Indiana Michigan
Power Company
500 Circle Drive
Buchanan, MI 49107 1373

AEP:NRC:2075-01
10 CFR 50.90

Donald C. Cook Nuclear Plant Units 1 and 2
SUPPLEMENT TO LICENSE AMENDMENT REQUEST REGARDING
CONTROL ROOM HABITABILITY

RESPONSE TO NUCLEAR REGULATORY COMMISSION (NRC) QUESTIONS
REGARDING LOCKED ROTOR ANALYSES

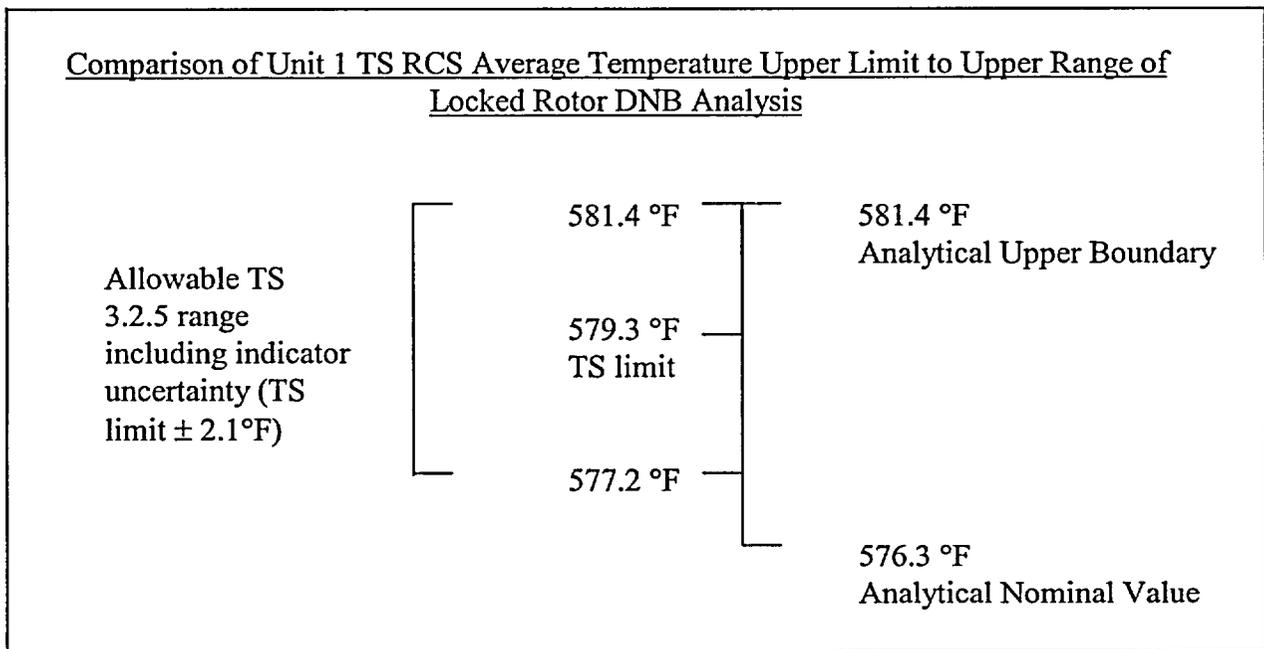
For the locked rotor DNB analysis for Unit 1 you assumed an initial pressure of 2100 psia and initial RCS average temperature of 576.3 degrees F. Your TS values for these parameters are 2050 psig and 579.3 degrees F. The values in your TS are non-conservative when compared to the values in the analysis. Please modify your TS to be consistent with the values used in the analyses.

As described in the following paragraphs, the values for RCS average temperature and pressurizer pressure in the Unit 1 Technical Specifications (TS) are conservative when compared to the values in the analysis. Therefore, I&M considers that the TS values do not need to be modified.

Unit 1 RCS Average Temperature

A high RCS average temperature promotes DNB. The locked rotor DNB transient analysis was performed for a nominal initial RCS average temperature of 576.3°F. Application, in accordance with the Revised Thermal Design Procedure (RTDP) (Reference 17), of a total uncertainty consisting of a ±4.1°F controller uncertainty, plus a +1.0°F bias for cold leg streaming, results in the analysis being valid for an RCS average temperature up to 581.4 °F.

The limiting condition for operation section of Unit 1 TS 3.2.5 requires that RCS average temperature be maintained less than or equal to 579.3°F. The RCS average temperature indication has an uncertainty of ±2.1°F. Therefore, the highest temperature possible while complying with TS 3.2.5 is 581.4°F. Consequently, the TS limit ensures that the value used in the locked rotor DNB analysis is not exceeded. This is illustrated in the figure below.
